City of Surrey  
**PLANNING & DEVELOPMENT REPORT**

Application No.: 7923-0125-00

Planning Report Date: May 15, 2023

- **Development Variance Permit**

# Appendix I

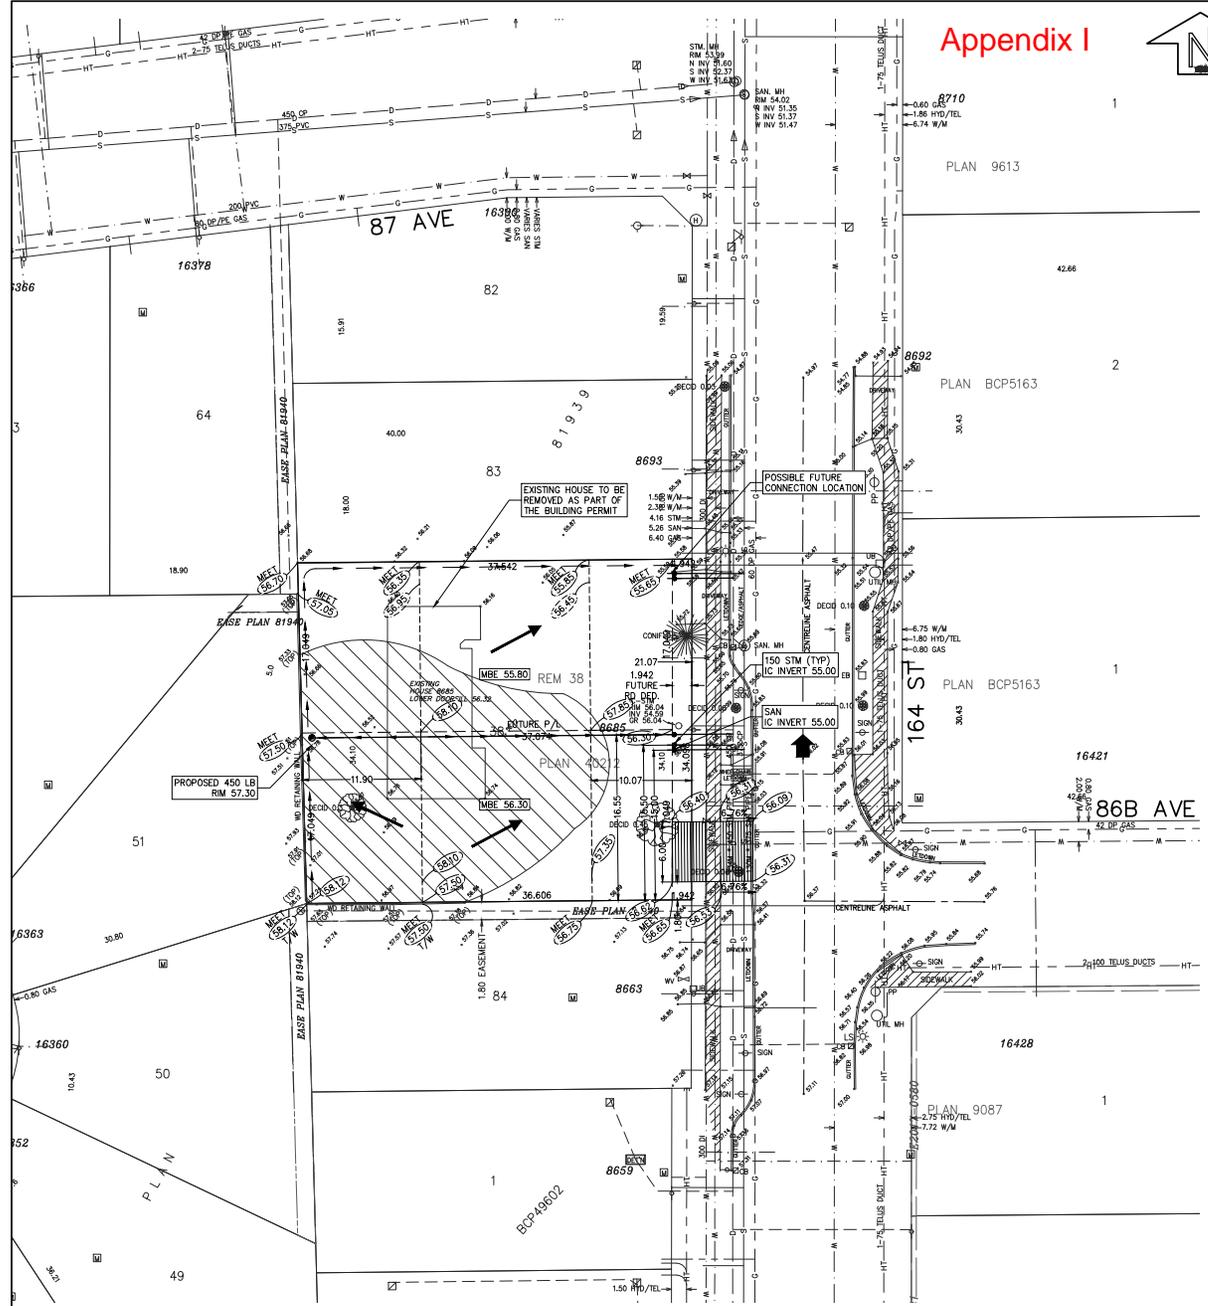
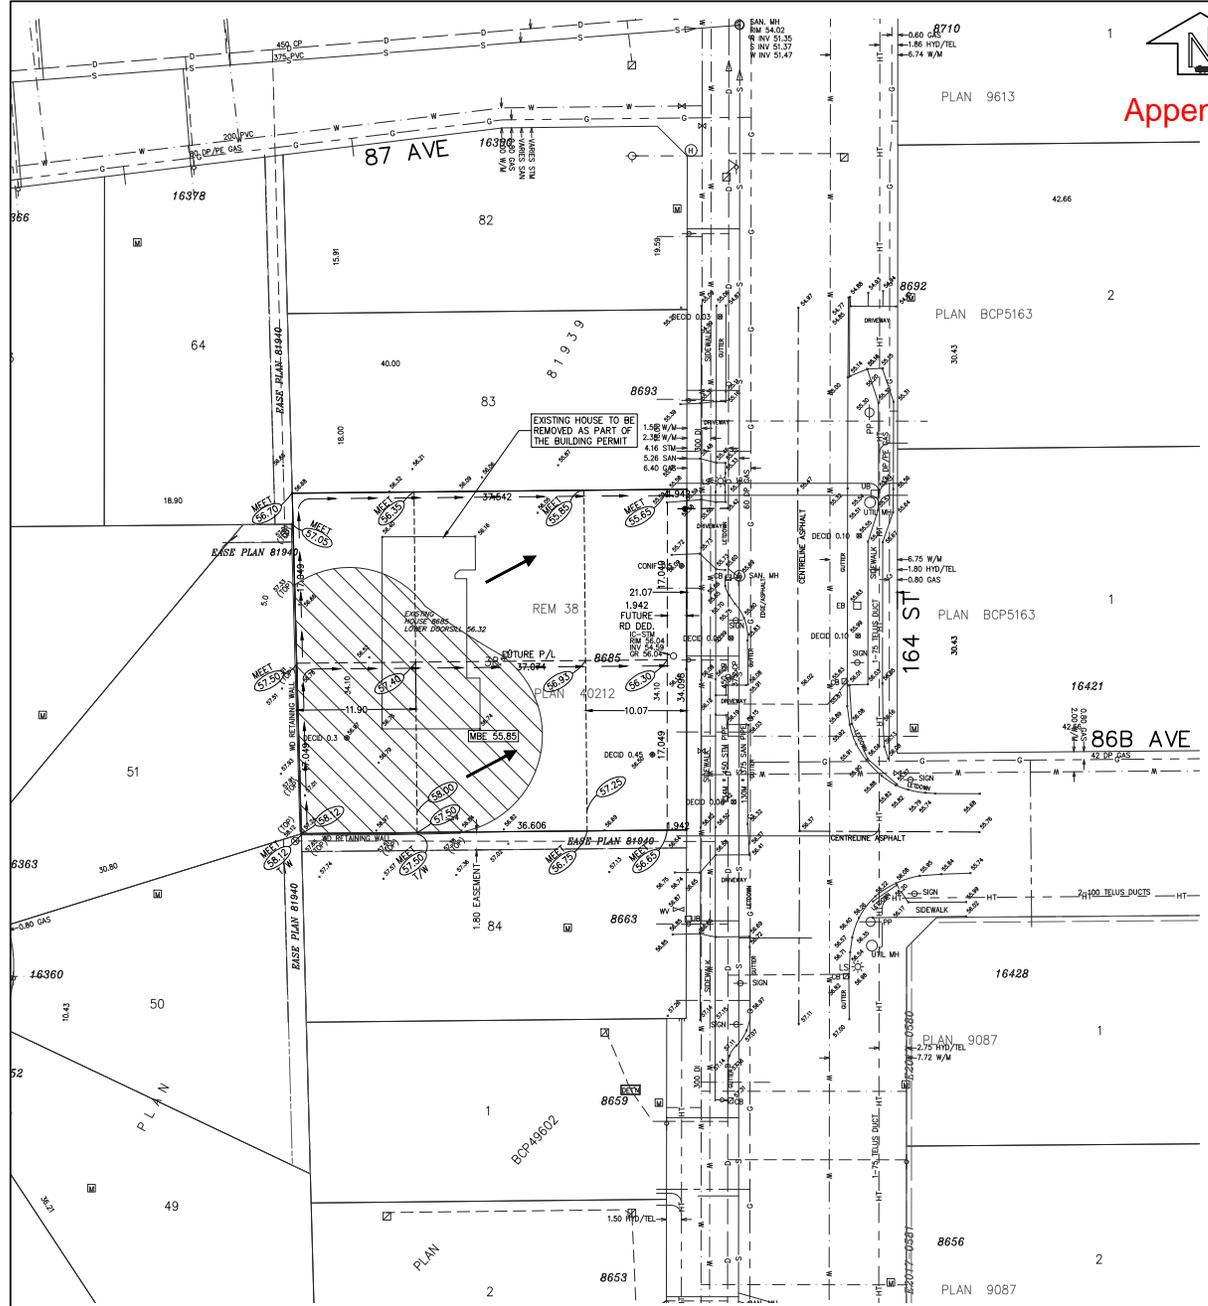
- Upon subsequent review of the approved revised lot grading plan under Development Application No. 7922-0185-00 (Appendix II), staff recommended that the applicant consider relocating the proposed service connections to reduce infrastructure costs. The applicant is also proposing additional fill on the property to potentially accommodate an in-ground basement. These changes have been incorporated into an updated revised lot grading plan (Appendix I).

- The proposed MBE of the updated revised lot grading plan under Development Application No. 7923-0125-00 is 56.30 metres (Appendix I). Additional fill is proposed to meet the existing grade at the top of the retaining walls along the south and west property lines.

- In order to achieve a 50% in-ground basement, the applicant is proposing to fill 0.6 metres at the south side of the proposed single family dwelling and 1.5 metres at the north side (Appendix I). The proposed fill will then grade down and meet the existing grades of the property. The rear of the proposed single family dwelling will drain into the northwest corner of the property through a lawn basin that will drain onto 164 Street.

- The applicant is seeking to construct their new house in advance of subdivision and is therefore requesting the subject variance to permit the use of the updated revised lot grading plan for the lot (Appendix I), in order to potentially achieve an in-ground basement.

Appendix II

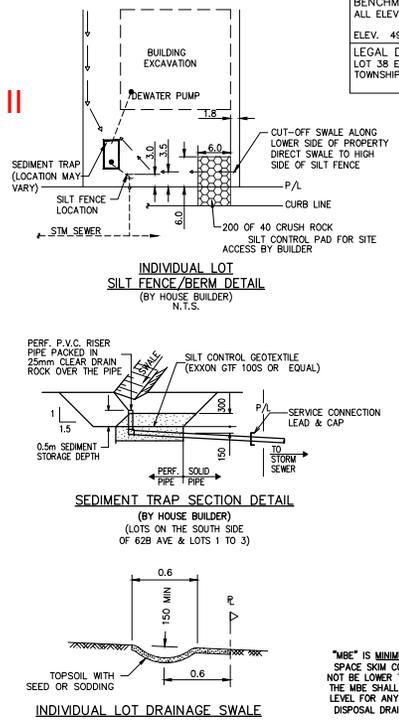
- The owners of the subject site applied for a building permit to build a new single family dwelling with a basement on the south side of the property. A revised lot grading plan (Appendix II) was submitted by CitiWest Consulting Ltd. proposing a minimum building elevation (MBE) of 55.85 metres, lower than the 56.24 metres approved in the original lot grading plan (Appendix III) submitted under Development Application No. 7988-0220-00. The revised proposed lot grading plan (Appendix II) was approved by Council on July 25, 2022.

Schedule A

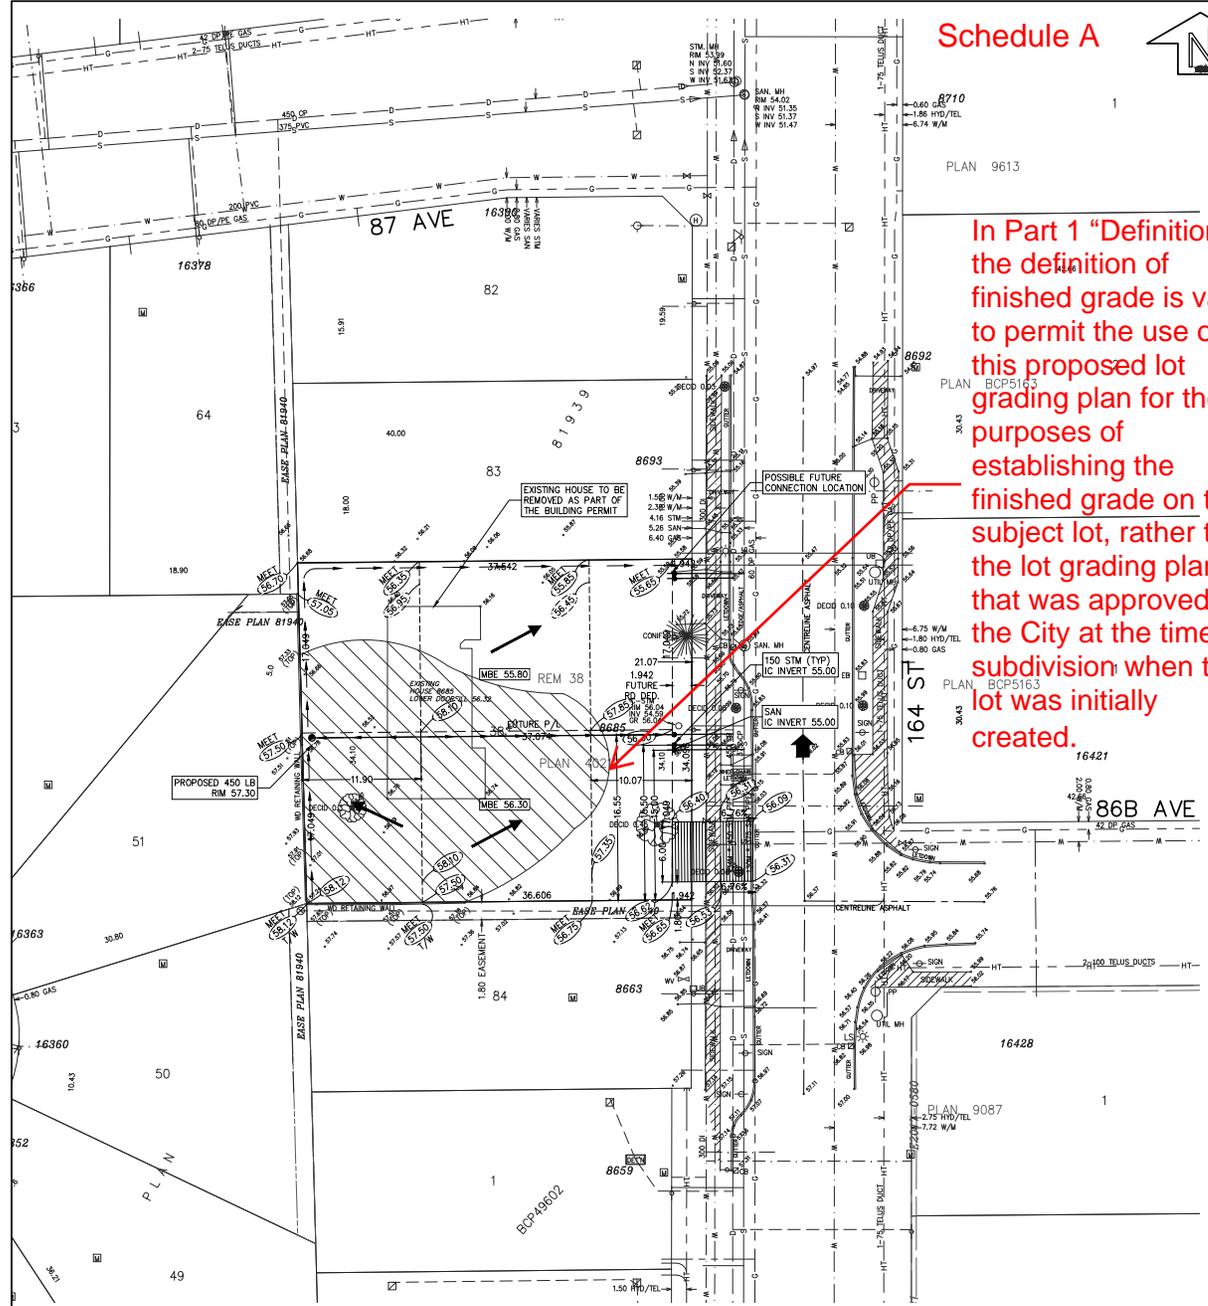
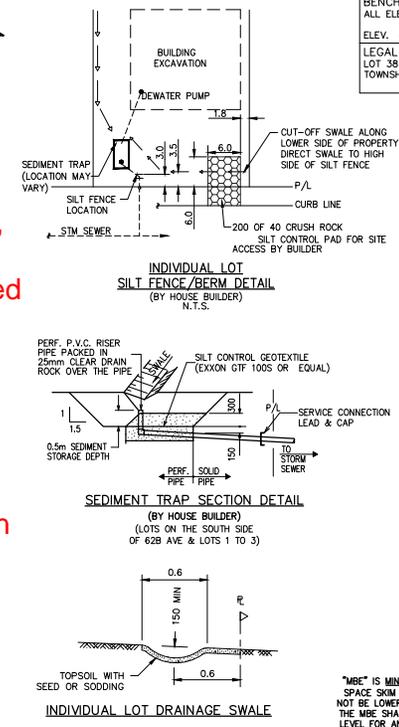
In Part 1 "Definitions", the definition of finished grade is varied to permit the use of this proposed lot grading plan for the purposes of establishing the finished grade on the subject lot, rather than the lot grading plan that was approved by the City at the time of subdivision when the lot was initially created.

3. Surrey Zoning By-law, 1993, No. 12000, as amended is varied as follows:
  - (a) In Part 1 "Definitions", the definition of *finished grade* is varied to permit the use of the proposed lot grading plan in Schedule A, which is attached hereto and forms part of this Development Variance Permit, for the purposes of establishing the finished grade on the subject lot, rather than the lot grading plan that was approved by the City at the time of subdivision when the lot was initially created.
4. This development variance permit applies to only the portion of the Land shown on Schedule A which is attached hereto and forms part of this development variance permit.
5. The Land shall be developed strictly in accordance with the terms and conditions and provisions of this development variance permit.
